Liverpool John Lennon Airspace Change

ACP-2015-09

Stage 2 Develop and Assess

Step 2ai and Step 2aii- Options Development and Design Principle Evaluation Addendum

Figure 12: The potential location for the VEGUN S1 PBN transition. The black line shows the original design and the Red swathe illustrates the updated design limits following feedback.

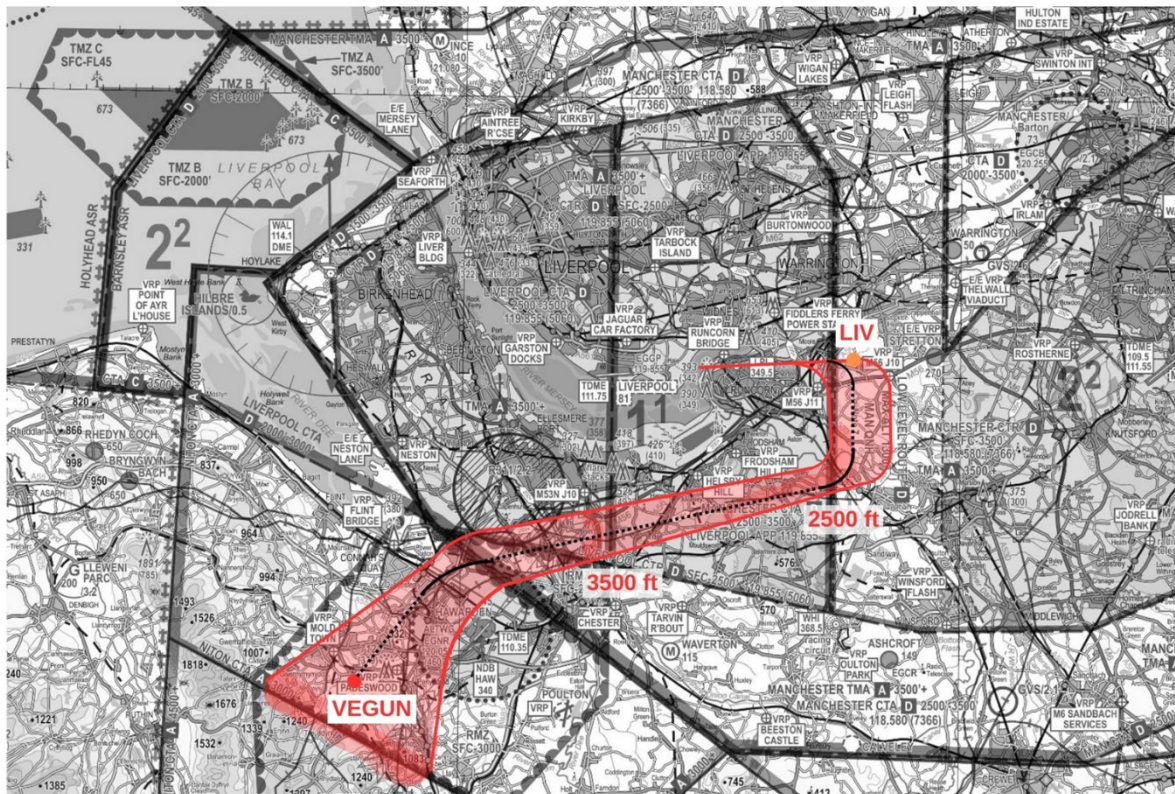
| Stakeholder | Feedback | Impact |
|--------------------|--|--|
| Manchester Airport | The designs for LPL arrivals to Runway 27 from the south previously advanced to Stage 4 included a base leg turn at 2,500ft requiring MAN southwest departures to reach 3,500ft at approximately 5nm before the base leg track to ensure separation. However, the climb gradient required by MAN departures to achieve this separation would be in excess of the 6% gradient that all airlines operating from MAN could achieve. | The levels presented within the presentation are indicative and subject to change during the option development work that takes place between the Stage 2 and Stage 3 gateways. However, LJLA note that current SIDs from Manchester airport runway 23 include initial climb gradients >12%. Whilst LJLA would not expect this rate to be included in the entirety of the Manchester SID design, Manchester departures are already required to have a climb performance in excess of 6% and therefore LJLA do not consider this to be a fair restriction on the design. An increased climb gradient can benefit ground-based stakeholders and should not be discounted at this stage. This and similar interactions will be considered through route separation workshops between the FASI sponsors as part of the ongoing design work required for the stage 3 submission. |

| Stakeholder | Feedback | Impact |
|------------------------|--|---|
| Wirral Borough Council | <p>New Option Combined Vegun 1 & Vegun 2 Comment: Neutral position as does not overfly the Borough.</p> | <p>The combination of VEGUN S1 and S2 is not included as an option. The slide was included to highlight the difference between the two options. Should both options progress then both could be implemented.</p> |

| Stakeholder | Feedback | Impact |
|---------------------------|--|---|
| Norley Parish Council | Norley Parish Council were delighted to be involved in the LJLA Stage 2 Engagement process The ACP Update Sheet was very useful as the VEGUN approaches materially affect Norley village Should you take the LJLA ACP further, Norley Parish Council would be pleased to be involved in the consultations | LJLA wishes to thank Norley Parish Council for their feedback. Norley Parish Council will be included in all future engagement and consultation relating to this ACP. |

Figure 13: The potential location for the VEGUN S1 PBN transition. The black line shows the original design and the blue swathe illustrates the updated design limits following feedback.

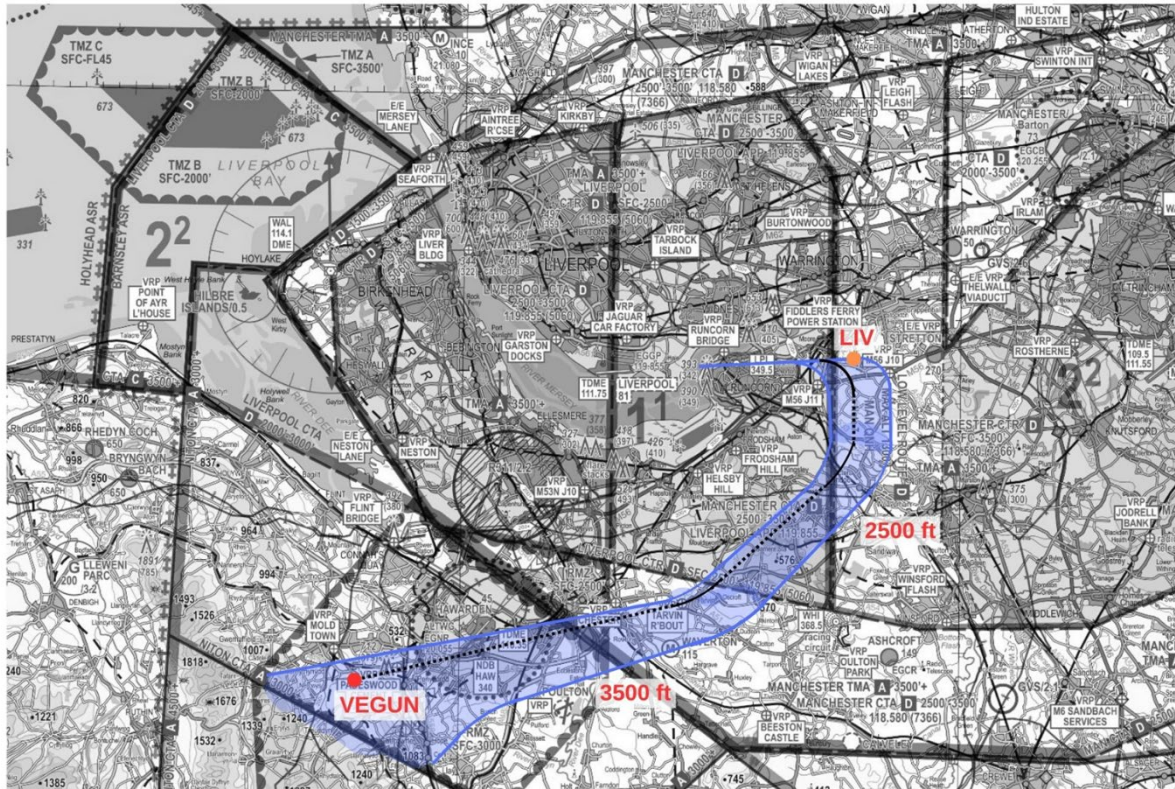
| Stakeholder | Feedback | Impact |
|--------------------|---|---|
| Manchester Airport | The designs for LPL arrivals to Runway 27 from the south previously advanced to Stage 4 included a base leg turn at 2,500ft requiring MAN southwest departures to reach 3,500ft at approximately 5nm before the base leg track to ensure separation. However, the climb gradient required by MAN departures to achieve this separation would be in excess of the 6% gradient that all airlines operating from MAN could achieve. | The levels presented within the presentation are indicative and subject to change during the option development work that takes place between the Stage 2 and Stage 3 gateways. However, LJLA note that current SIDs from Manchester airport runway 23 include initial climb gradients >12%. Whilst LJLA would not expect this rate to be included in the entirety of the Manchester SID design, Manchester departures are already required to have a climb performance in excess of 6% and therefore LJLA do not consider this to be a fair restriction on the design. An increased climb gradient can benefit ground-based stakeholders and should not be discounted at this stage. |

| Stakeholder | Feedback | Impact |
|------------------------|--|---|
| Wirral Borough Council | <p>New Option Combined Vegun 1 & Vegun 2 Comment: Neutral position as does not overfly the Borough.</p> | <p>The combination of VEGUN S1 and S2 is not included as an option. The slide was included to highlight the difference between the two options. Should both options progress then both could be implemented.</p> |

| Stakeholder | Feedback | Impact |
|---------------------------|--|--|
| Norley Parish Council | Norley Parish Council were delighted to be involved in the LJLA Stage 2 Engagement process The ACP Update Sheet was very useful as the VEGUN approaches materially affect Norley village Should you take the LJLA ACP further, Norley Parish Council would be pleased to be involved in the consultations | LJLA wishes to thank Norley Parish Council for their feedback. Norley Parish Council will be included in all future engagement and consultation relating to this ACP. |

Figure 14: The potential location for a SID departing runway 09 with a right turn to join the ATS network in the North East.

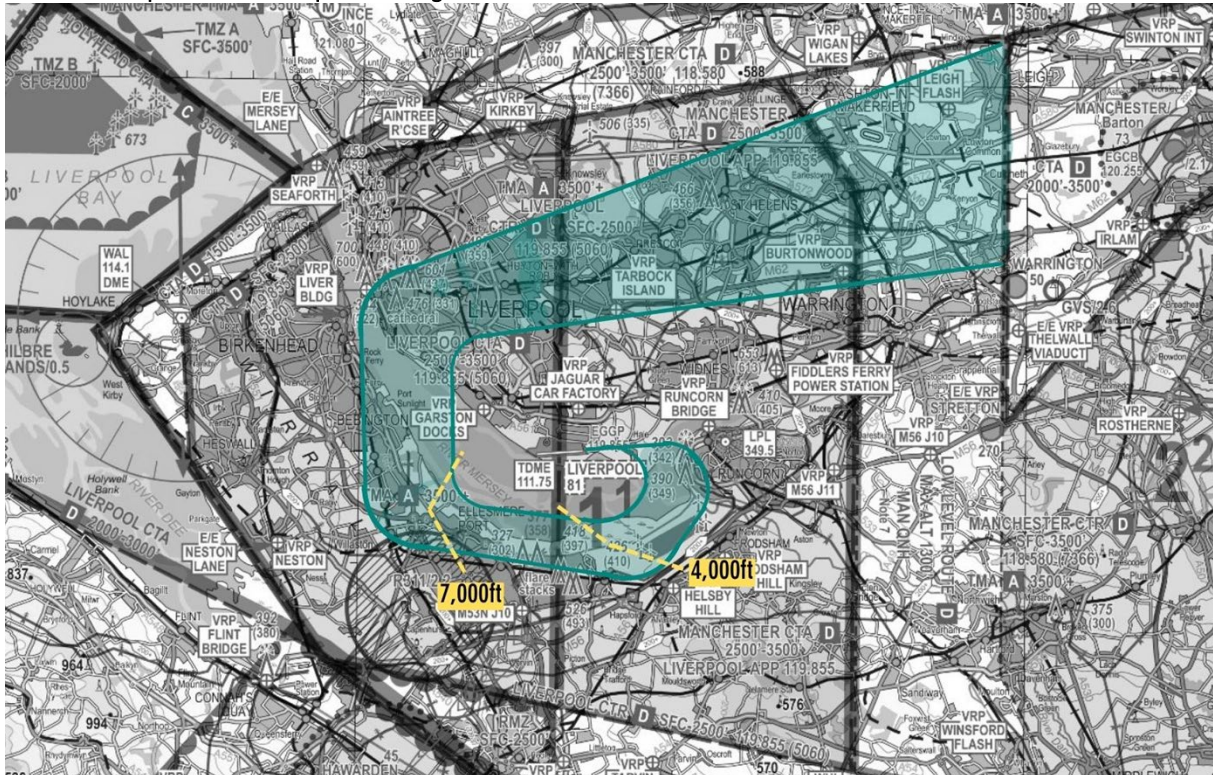
| Stakeholder | Feedback | Impact |
|-----------------------------|---|--|
| Liverpool City Council | With regards to some of the 09 Departure options, the turn to the right seems to take planes over the Mersey estuary more, compared with the equivalent left turns which take planes over densely populated areas of south Liverpool. | <p>LJLA agrees with this assessment, and it will be reflected in the DPE (DP 3, 4 and 13).</p> <p>However, the conceptual nature of the design options means that specific design decisions as a result of this feedback cannot be made until more detailed options are developed in Stage 3.</p> |
| NERL | NATS NERL (MTMA) has no 'local factors' knowledge that may or may not apply or influence LJL options to 7000ft and is unable to comment on such aspects however, the additional departure swathes presented in this engagement indicatively suggest NERL network compatibility both within | LJLA wishes to thank the NERL for their feedback. No update required to Design at this stage. |

Figure 15: The potential location for a SID departing runway 09 with a left turn to join the ATS network in the Northeast.

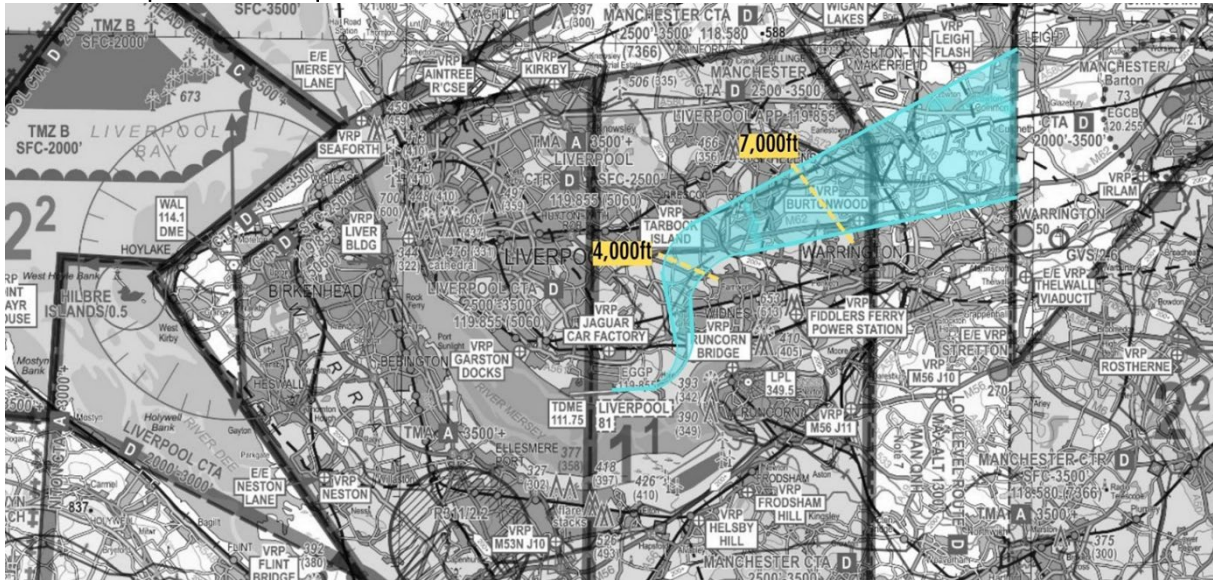
| Stakeholder | Feedback | Impact |
|-----------------------------|--|---|
| Liverpool City Council | With regards to some of the 09 Departure options, the turn to the right seems to take planes over the Mersey estuary more, compared with the equivalent left turns which take planes over densely populated areas of south Liverpool. | <p>LJLA agrees with this assessment, and it will be reflected in the DPE (DP 3, 4 and 13).</p> <p>However, the conceptual nature of the design options means that specific design decisions as a result of this feedback cannot be made until more detailed options are developed in Stage 3.</p> |
| NERL | NATS NERL (MTMA) has no 'local factors' knowledge that may or may not apply or influence LJL options to 7000ft and is unable to comment on such aspects however, the additional departure swathes presented in this engagement indicatively suggest NERL network compatibility both within the requirements of a Stage 2 ACP and in terms of option(s) flexibility that remains to be fully determined within the indicative swathes utilising Route Separation and Cumulative Assessment Framework technical collaborative assessment with relevant ACP stakeholders. | LJLA wishes to thank the NERL for their feedback. No update required to Design at this stage. |

Figure 16: The potential location for a SID departing runway 09 with a right turn to join the ATS network in the South.

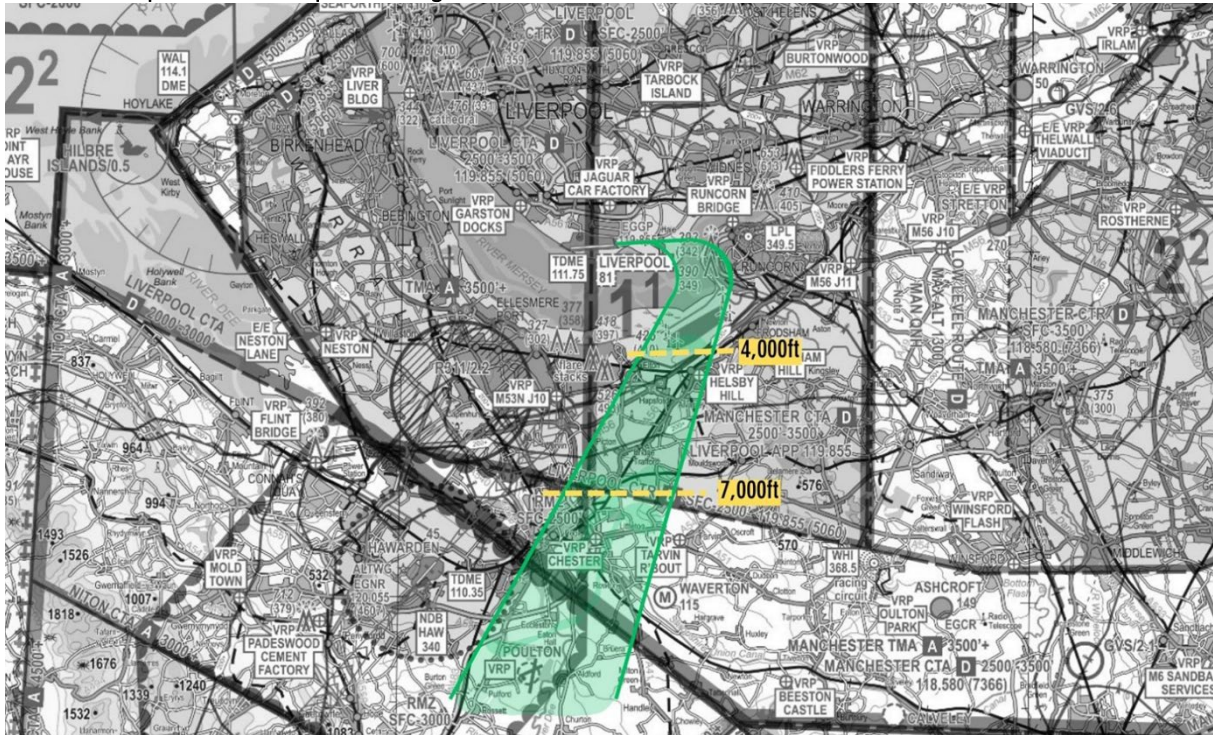
| Stakeholder | Feedback | Impact |
|-----------------------------|--|---|
| Liverpool City Council | With regards to some of the 09 Departure options, the turn to the right seems to take planes over the Mersey estuary more, compared with the equivalent left turns which take planes over densely populated areas of south Liverpool. | <p>LJLA agrees with this assessment, and it will be reflected in the DPE (DP 3, 4 and 13).</p> <p>However, the conceptual nature of the design options means that specific design decisions as a result of this feedback cannot be made until more detailed options are developed in Stage 3.</p> |
| NERL | NATS NERL (MTMA) has no 'local factors' knowledge that may or may not apply or influence LJA options to 7000ft and is unable to comment on such aspects however, the additional departure swathes presented in this engagement indicatively suggest NERL network compatibility both within the requirements of a Stage 2 ACP and in terms of option(s) flexibility that remains to be fully determined within the indicative swathes utilising Route Separation and Cumulative Assessment | LJLA wishes to thank the NERL for their feedback. No update required to Design at this stage. |

Figure 17: The potential location for a SID departing runway 09 with a left turn to join the ATS network in the South.

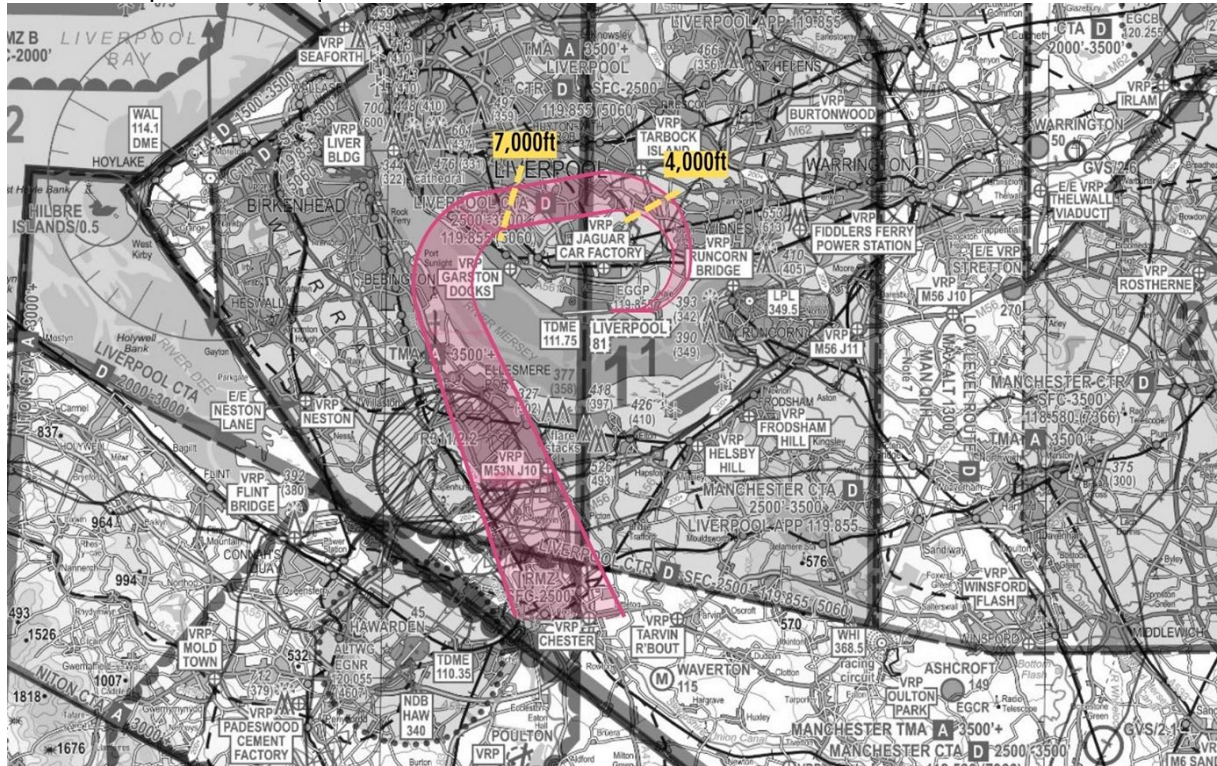
| Stakeholder | Feedback | Impact |
|-----------------------------|--|---|
| Liverpool City Council | With regards to some of the 09 Departure options, the turn to the right seems to take planes over the Mersey estuary more, compared with the equivalent left turns which take planes over densely populated areas of south Liverpool. | <p>LJLA agrees with this assessment, and it will be reflected in the DPE (DP 3, 4 and 13).</p> <p>However, the conceptual nature of the design options means that specific design decisions as a result of this feedback cannot be made until more detailed options are developed in Stage 3.</p> |

| Stakeholder | Feedback | Impact |
|------------------------|--|---|
| NERL | NATS NERL (MTMA) has no 'local factors' knowledge that may or may not apply or influence LJL options to 7000ft and is unable to comment on such aspects however, the additional departure swathes presented in this engagement indicatively suggest NERL network compatibility both within the requirements of a Stage 2 ACP and in terms of option(s) flexibility that remains to be fully determined within the indicative swathes utilising Route Separation and Cumulative Assessment Framework technical collaborative assessment with relevant ACP stakeholders. | LJLA wishes to thank the NERL for their feedback. No update required to Design at this stage. |

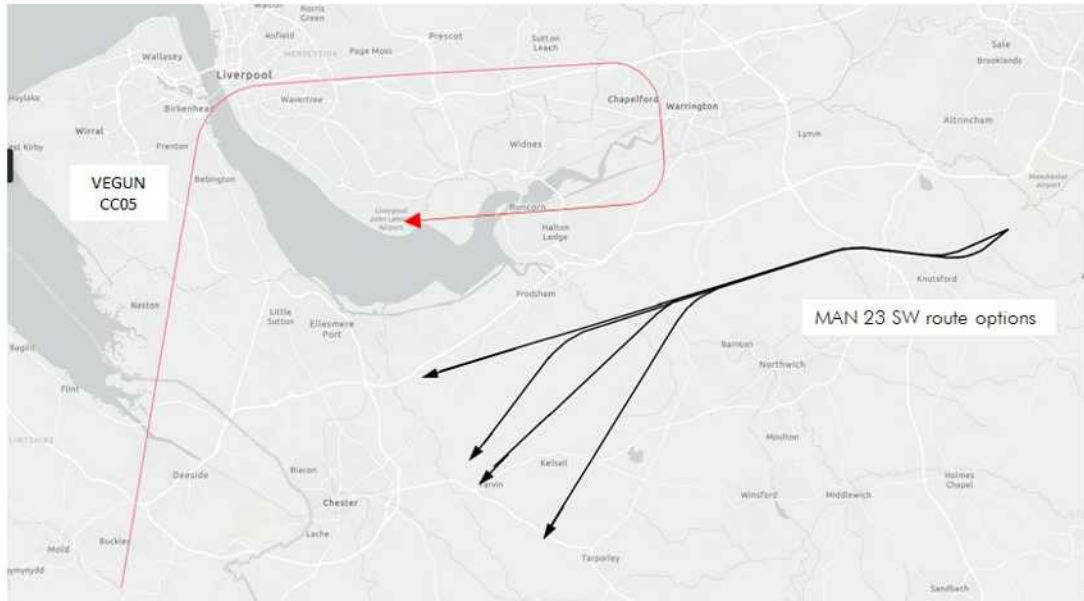
However, LPL has an existing PBN procedure (LNAV/VNAV) to Runway 27 which is detailed within the UK AIP (AD2 -EGGP 8-8) and which has a FAF at UVERI at 2,000ft. Utilising this existing UVERI FAF as part of the arrival design options would have the effect of moving the LPL base leg track further west. Because traffic would be at a lower altitude, it would increase separation from the proposed MAN departure tracks.

To achieve this, 3 additional transitions should be created, using the initial part of the routes of the original VEGUN, VEGUN S1 and VEGUN S2 but turning north earlier to intercept a 2,000ft FAF at UVERI. These are shown schematically below.

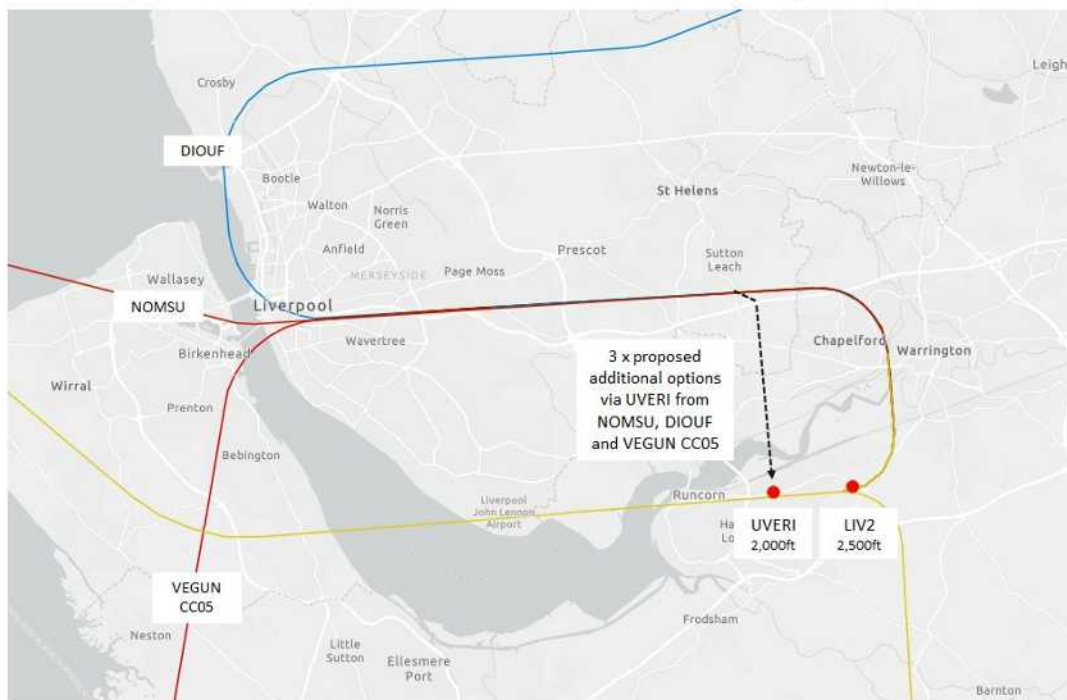
2.1. Create additional options for Runway 27 downwind RH transitions which require aircraft to be at 2,000ft before the base leg turn.

These options would have the effect of reducing the altitude of LPL traffic earlier, such that MAN Runway 23SW departures would only require to be 3,000ft 5nm before the base leg track. We would expect this to reduce the required climb gradient for MAN traffic to one that is achievable by a wider range of all aircraft operating at MAN but further separation analysis work would be required to confirm this.
